# CITY OF ALBUQUERQUE

**RE: Presbyterian Paradise Clinic (File: C12D003B7)**  
**Grading and Drainage Plan**  
**Engineer's Stamp Date – NO Stamp**

Based upon the information provided in your submittal received 7-10-15, the above referenced plan is approved for Site Plan for Building Permit action by the DRB with the following condition.

DRAWN BY	BO
REVIEWED BY	GSB
DATE	06/25/2015
PROJECT NO.	15-0028
DRAWING NAME	DRAINAGE MANAGEMENT PLAN
SHEET NO.

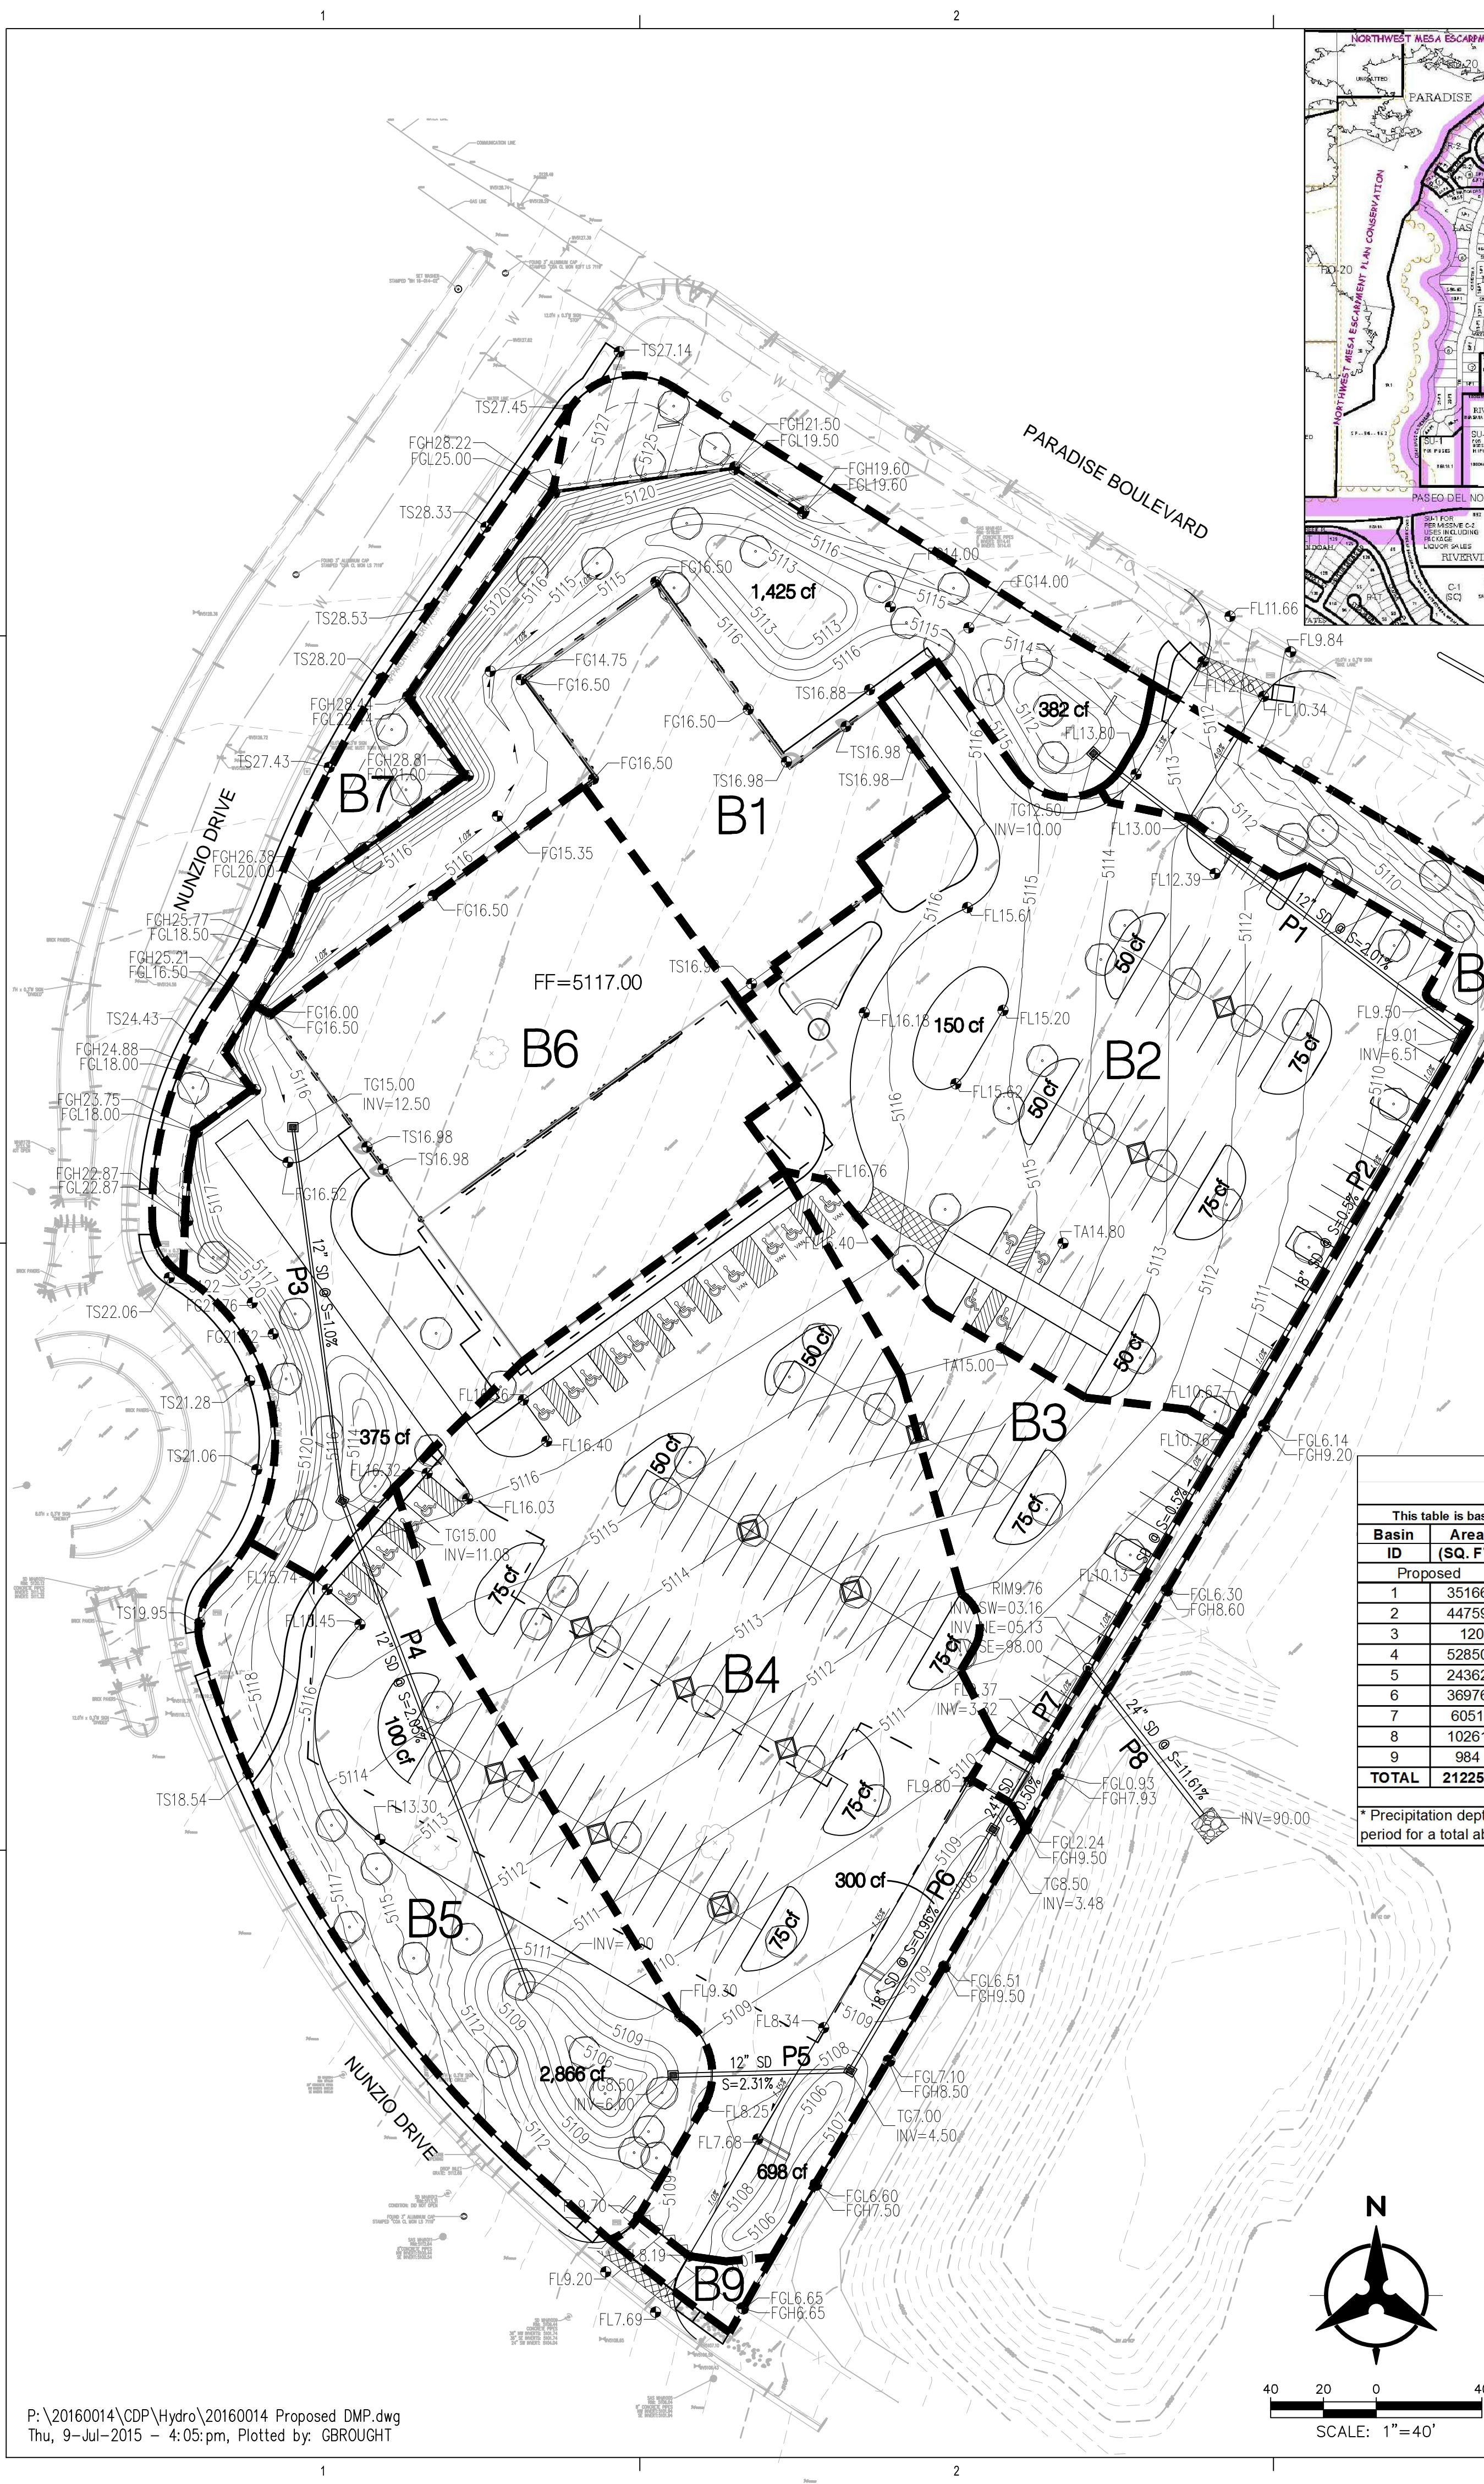
1. Approval by AMAFCA for the license agreement is required for Building Permit.

The plans still need to be reviewed for Building Permit, and the plans need to be stamped.
